TITLE <b>XD10P Ground Fix</b>		NUMBER <b>TN-F441</b>	REV <b>C</b>	PAGE 1 of 2
	DEPARTMENT Engineering	CREATED BY: K. Hultgren	EFFECTIVE DATE 4/05/06	APPROVED BY:

DTS, 5171 Clareton Dr., Agoura Hills, CA 91301 Contact Document Control for the latest revision.

Figure 1

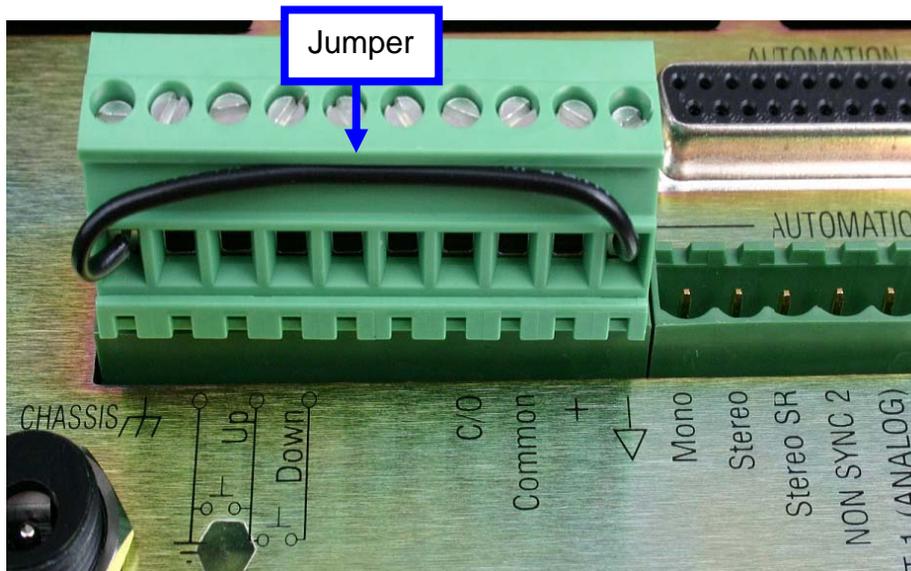
XD10P units produced until April 2006 have an open ground inside the unit. This open ground can produce noise in some installations. In most cases, simply adding a jumper between chassis ground and analog ground on a rear panel Phoenix connector will fix the problem. See Figure 1.

Units produced after April 2006 and after will have the grounds tied together inside the unit. Units produced before April 2006 that are having noise issues, will require a jumper added to the Phoenix connector, as shown below.

Some XD10P shipments in March – April 2006 will come with jumpers pre-installed on Phoenix connectors. Care should be taken when installing the Phoenix connectors to the back of the unit. Please make sure to put the Phoenix connector with the jumper on the left header. Putting the connector on the right header will lock the XD10P into the SR mode.

Figure 2

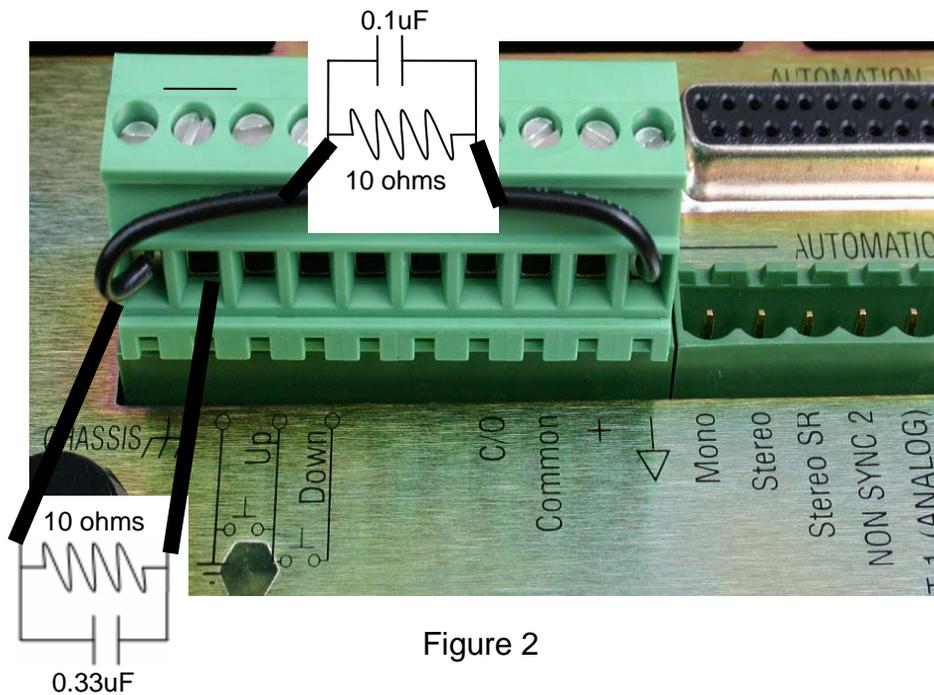
If the noise persists after adding the jumper between grounds, you must add two RC circuits between the grounds as shown in Figure 2.

- Add a 0.1uF capacitor in parallel with a 10 ohm ¼ watt resistor between chassis and digital grounds (adjacent to each other) on the Phoenix connector.
- Add a 0.33uF capacitor in parallel with a 10 ohm ¼ watt resistor between chassis and analog ground on the Phoenix connector.
